RE: Seabrook Station  
Docket No. 50-443  
Renewed Facility Operating License No. NPF-86

Response to Requests for Additional Information (RAIs) Regarding Updated Final Response to  
NRC Generic Letter 2004-02

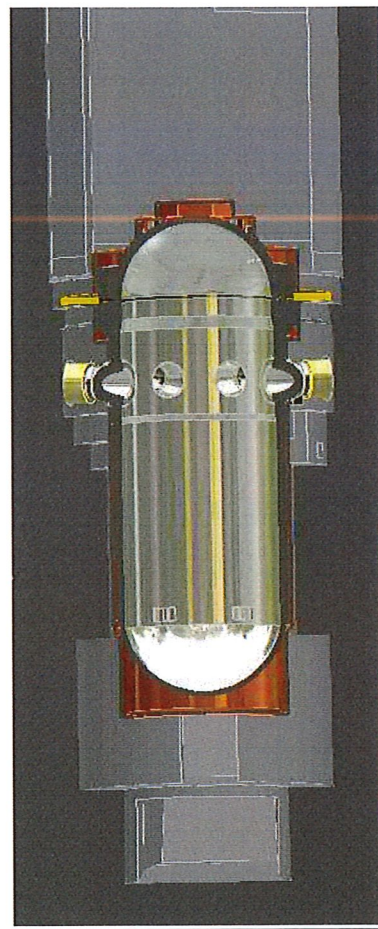
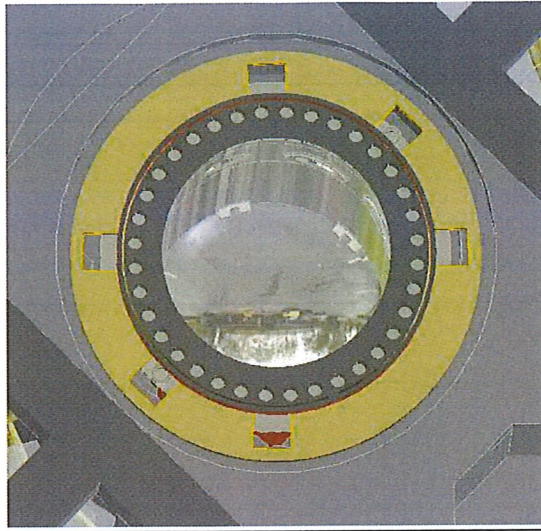
On page E1-20 of the submittal dated June 24, 2021, the licensee credited the reactor cavity seal ring for protection of insulation on the reactor head. Provide details that justify that the seal ring is a robust structure capable of shielding insulation on the reactor head from breaks in the reactor cavity.

A vertical cross section of Unit 1's reactor cavity and a plan view of the reactor vessel are shown below. The reactor cavity seal ring is yellow in the figures.

The geometry and structural integrity of the reactor cavity and pressurized flow piping relative to the location of the shielding insulation on the reactor head makes dislodging of any insulation from the reactor head extremely unlikely. The reactor cavity seal ring (RCSR) spans the annulus between the reactor vessel seal ledge and the refueling cavity floor. It functions as both a watertight seal and a shield to reduce radiation levels. The top plate seal ring is a continuous ring 1-½ inch (nominal) thick. Below, the neutron / gamma shield consists of two 10 inch thick sections of borated concrete poured into a carbon steel support assembly in a two-tier configuration. Both sections contain a 3/8 inch horizontal steel plate. The seal ring assembly weighs 53,660 lbs.

Any break jet within the cavity would initiate below the reactor cavity seal ring, which is situated at the bottom of the reactor head. The jet could reflect off of the reactor vessel and reactor cavity walls before discharging upward through the openings in the RCSR. At this point, the jet would freely expand to upper containment without damaging the insulation on the reactor vessel head.
